City of Seattle

DESIGN
REVIEW

DATE: 8/17/2017
TO: Lucas Branham and Tony Fan
FROM: Magda Hogness
RE: Recommendation Meeting Packet (3020338)

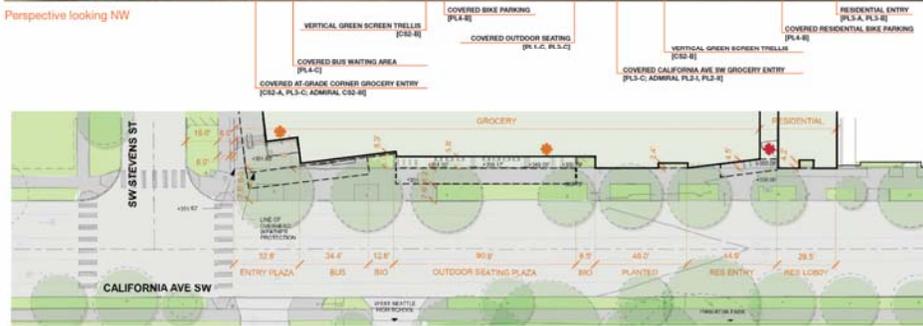
- For the streetscape/gathering space along Madison, provide more detail on the composite landscape plan on pg 21. Include material paving notes, design of seating types, and other special features. See embedded images from MUP 3024077 as an example.
